Date: September 11th, 2024

Project: All Seasons Arena Renovation	City Project No.: 11075 State Project No.:
Contractor: Met-Con Construction	Date of Contract:

Description: Change Order 006 –

SHEET
A2-11

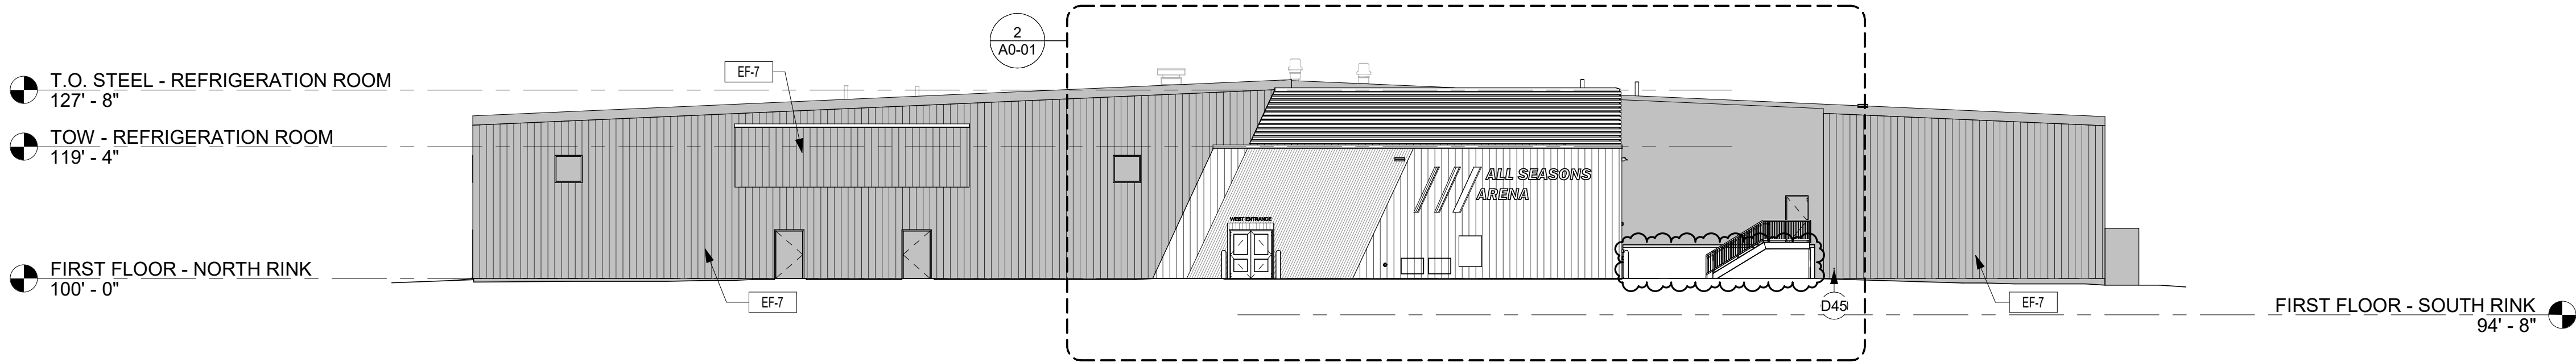
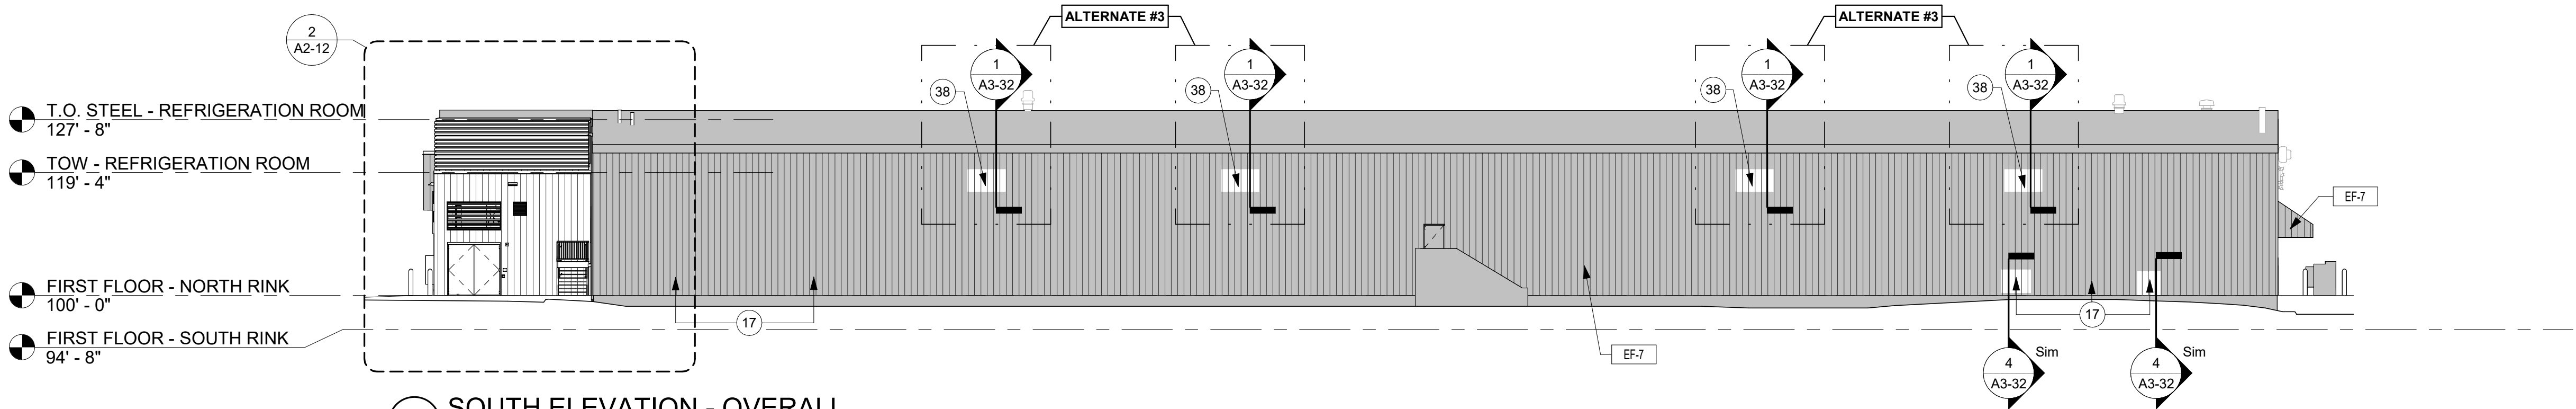
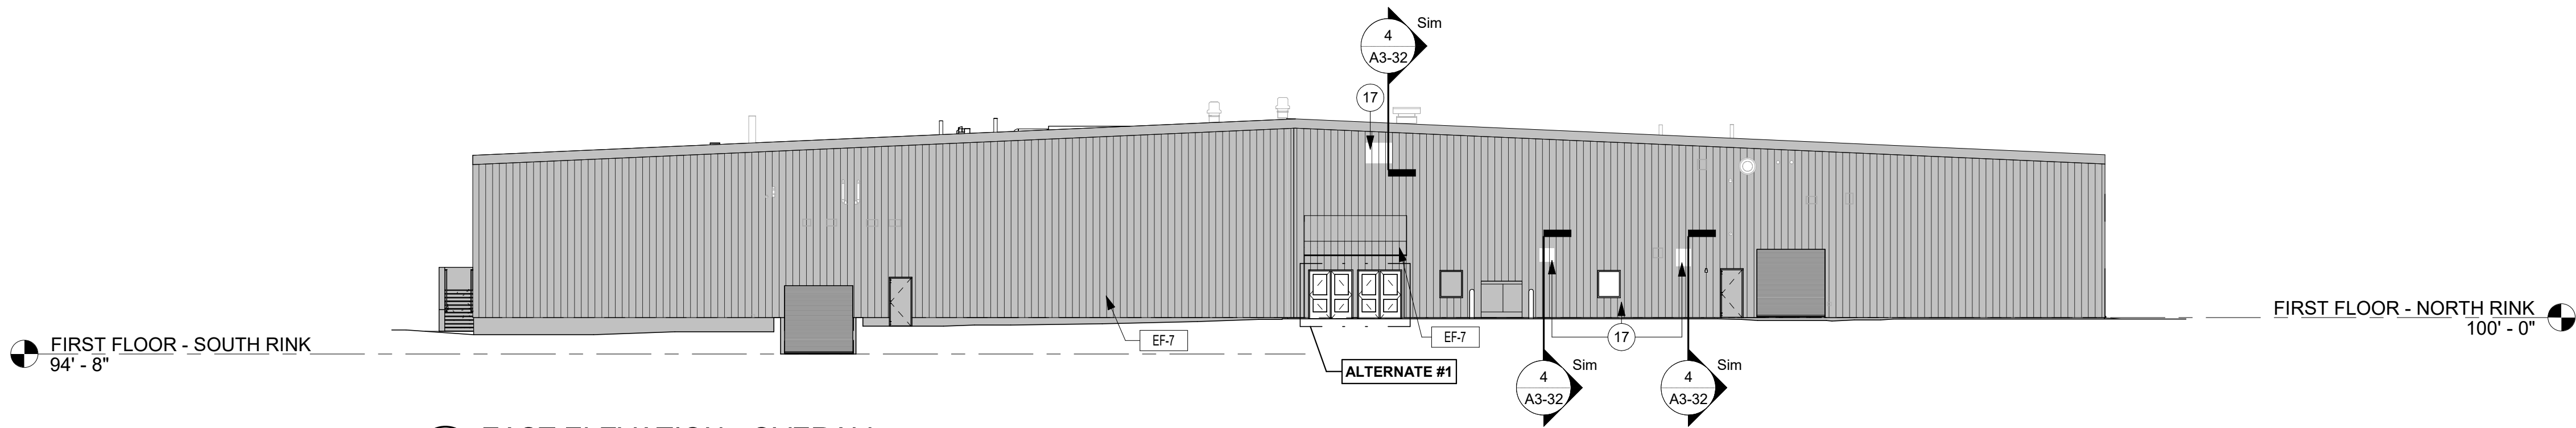
- b. Added detail callout 6/A3-30.
5. Refer to revised Plan Sheet A2-11 – Exterior Elevations
 - a. Revised west stone wall and west stair of the South Rink.

6 SECTION THRU WEST STONE WALL
1 1/2" = 1'-0"

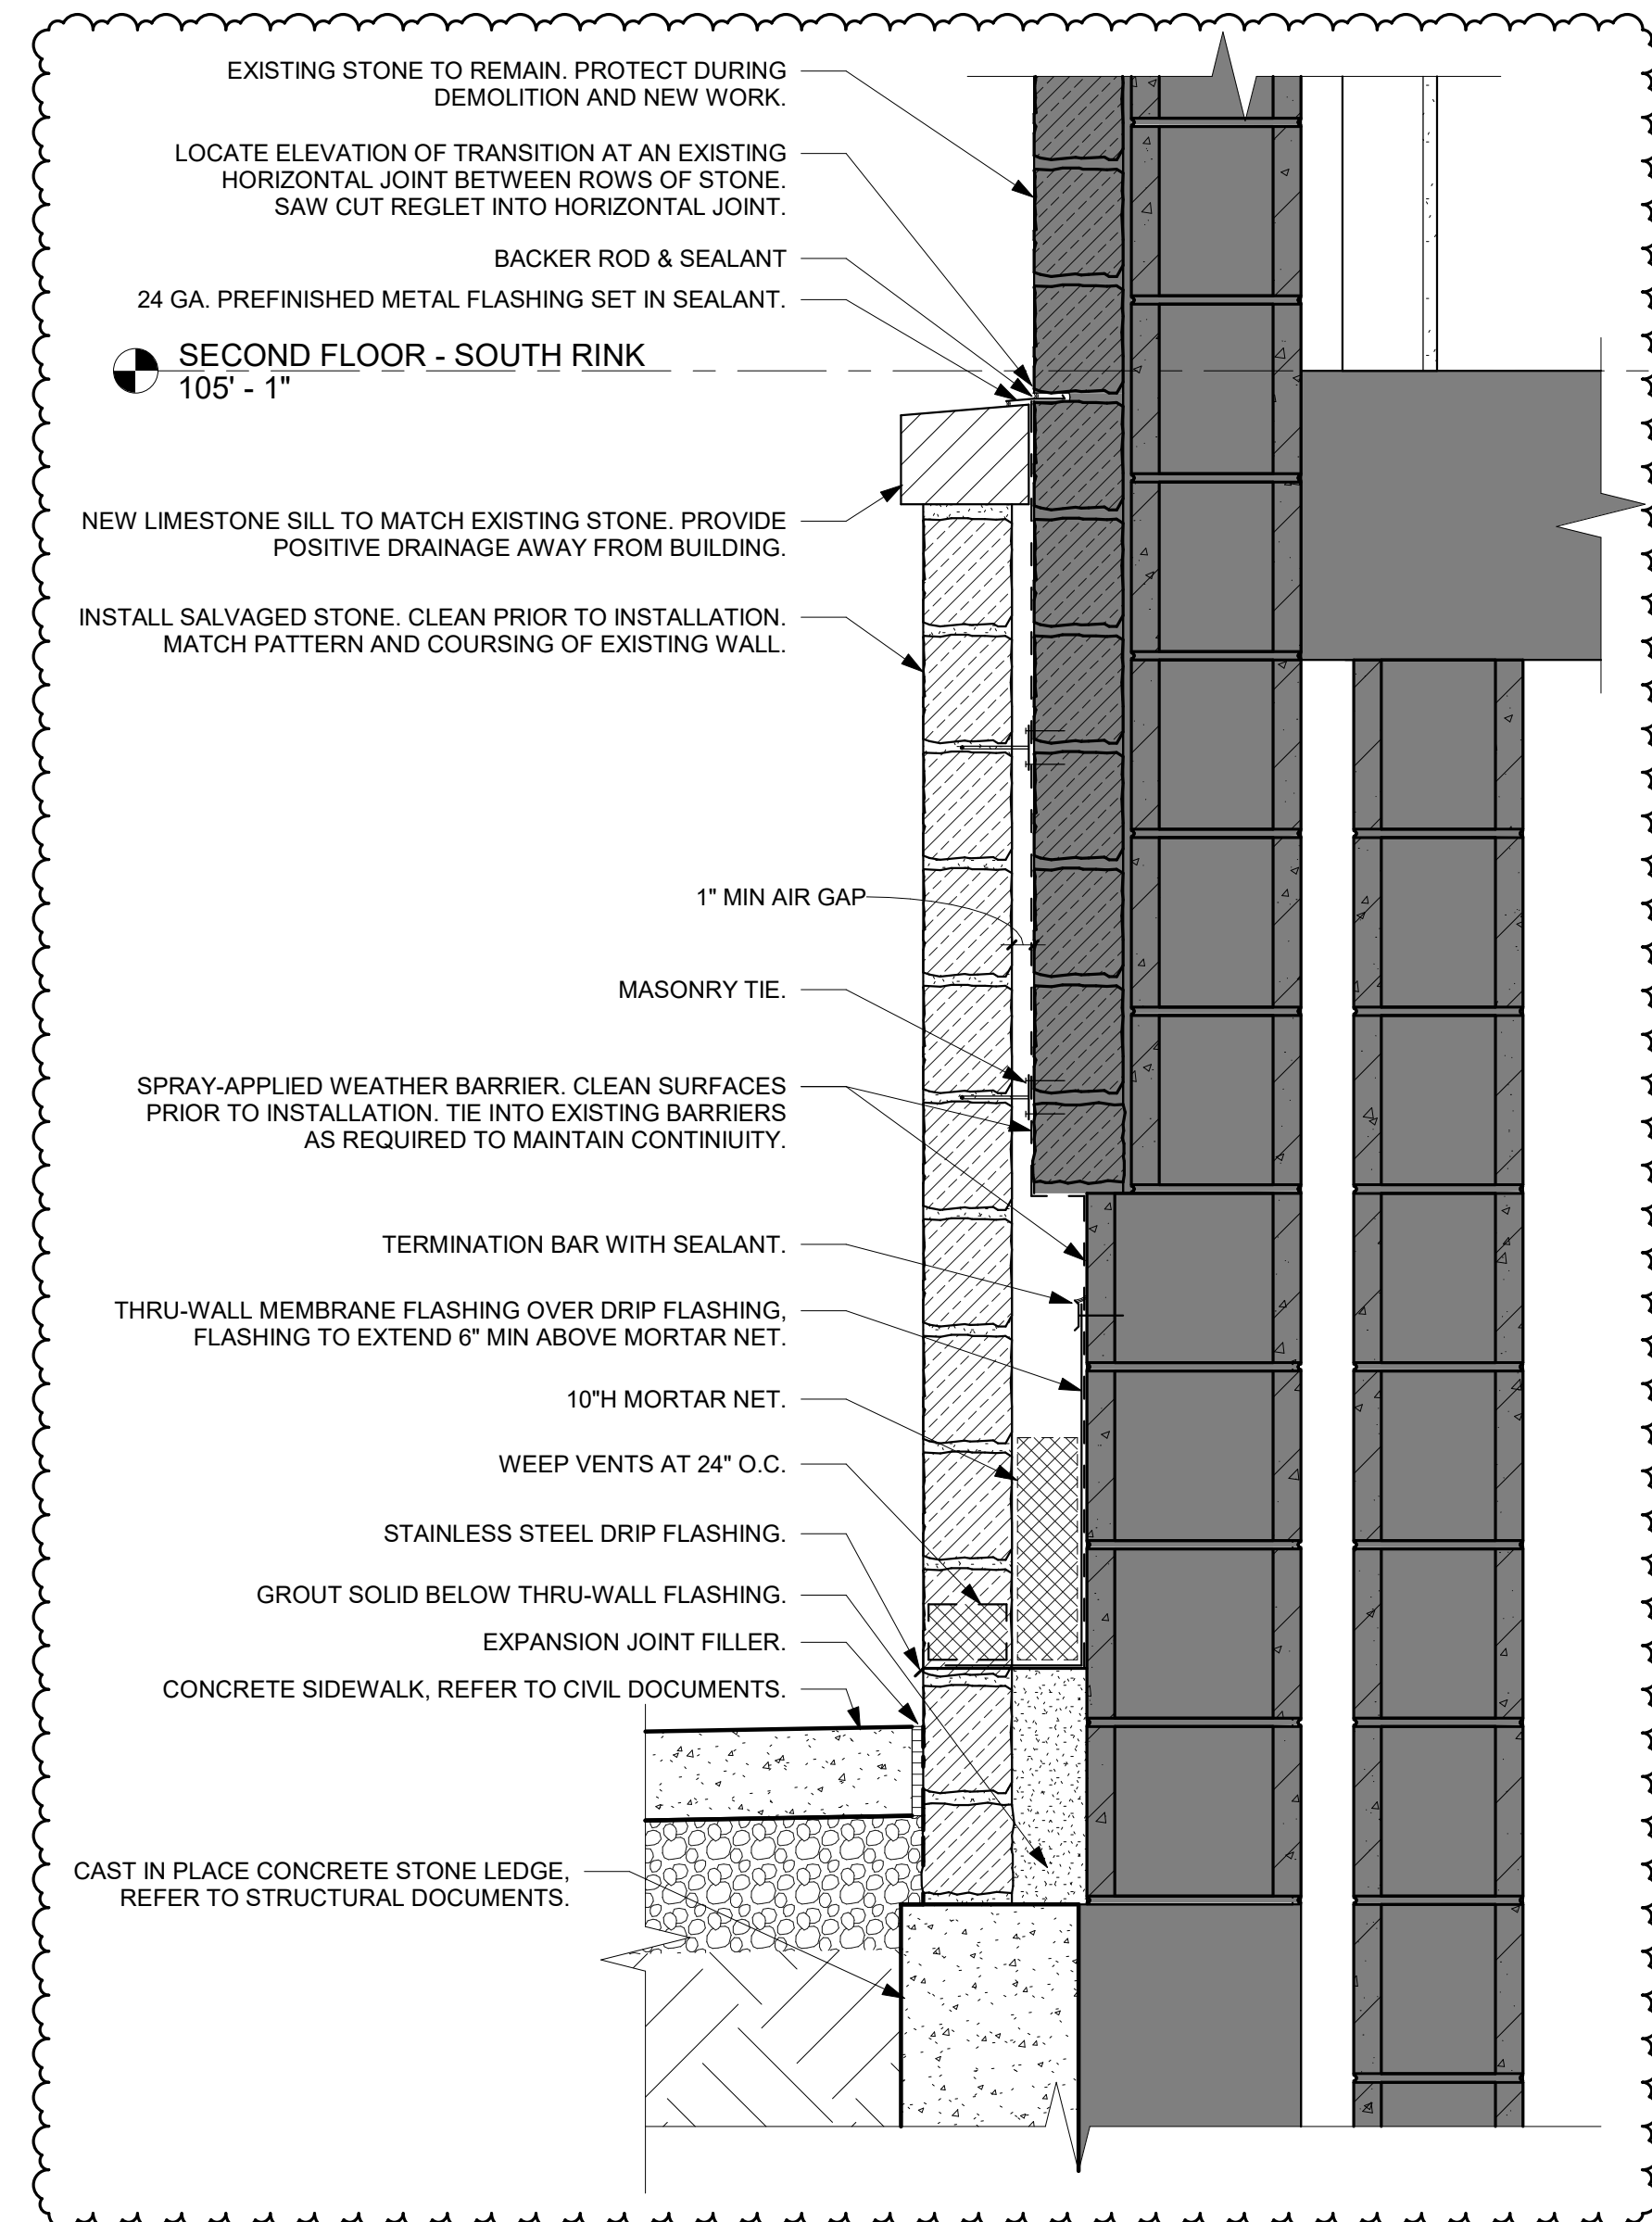
- c. Added detail callout 6/A3-30.
7. Refer to revised Plan Sheet A3-30 – Plan Details
 - a. Added detail 6: Section Thru West Stone Wall
8. Refer to revised Plan Sheet A7-12 – Enlarged Vertical Circulation Sections

FOUNDATION PLAN - AREA C

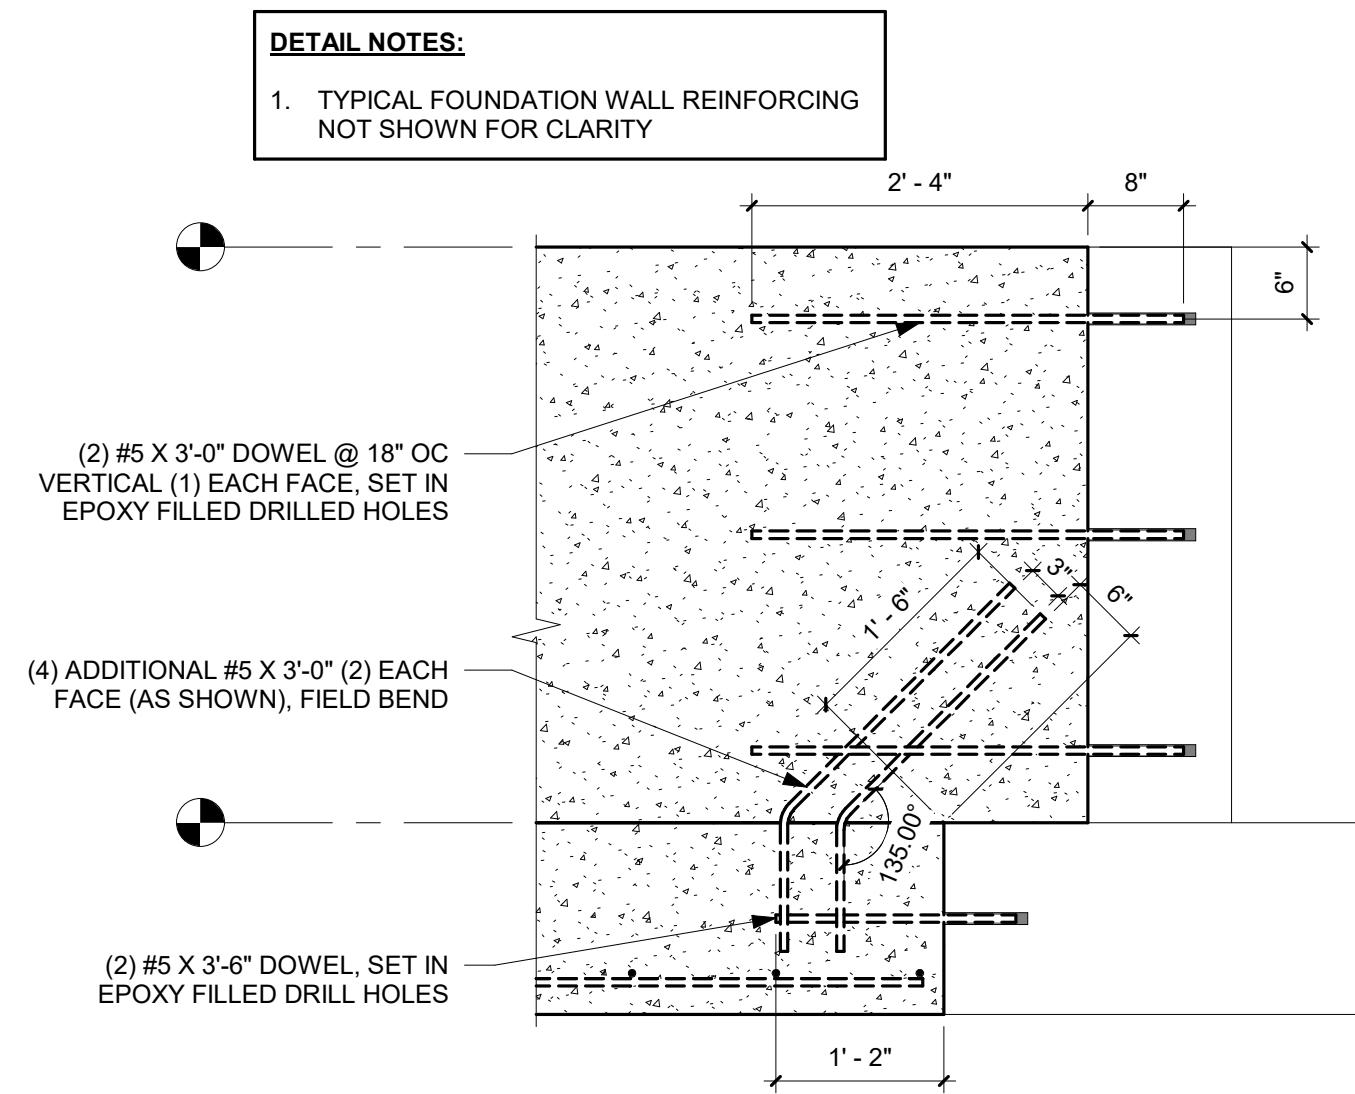
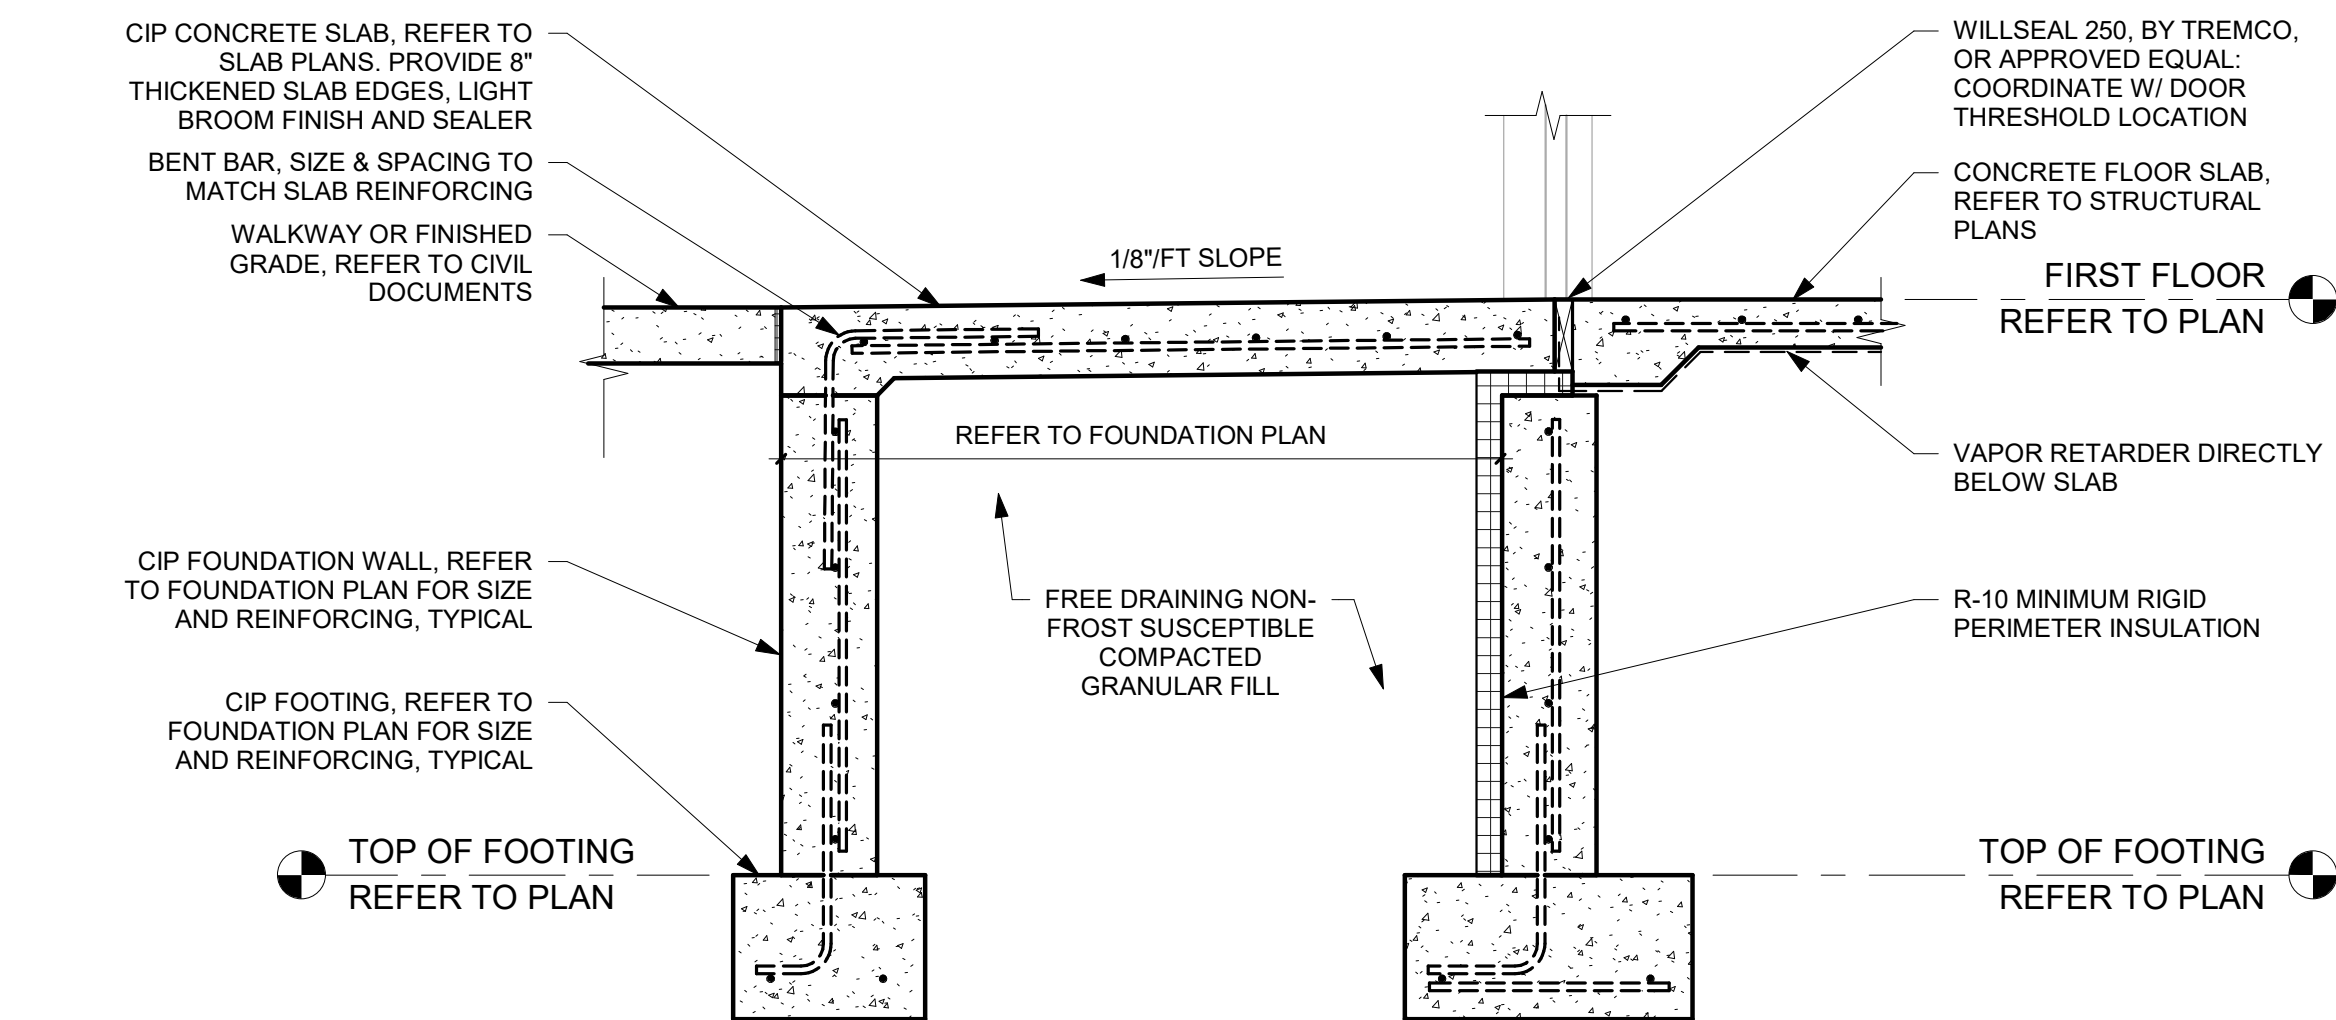
- a. Revised stair to shift west 4” for addition of stone wall.
9. Refer to revised Plan Sheet S1-11C – Foundation Plan – Area C
 - a. Revised exterior west stair of the south rink support locations for stone wall

- i. Revised pier spacing to coordinate with stone wall
 - b. Added cast in place concrete stone ledge detail for stone wall support
 - c. Added keynote 97
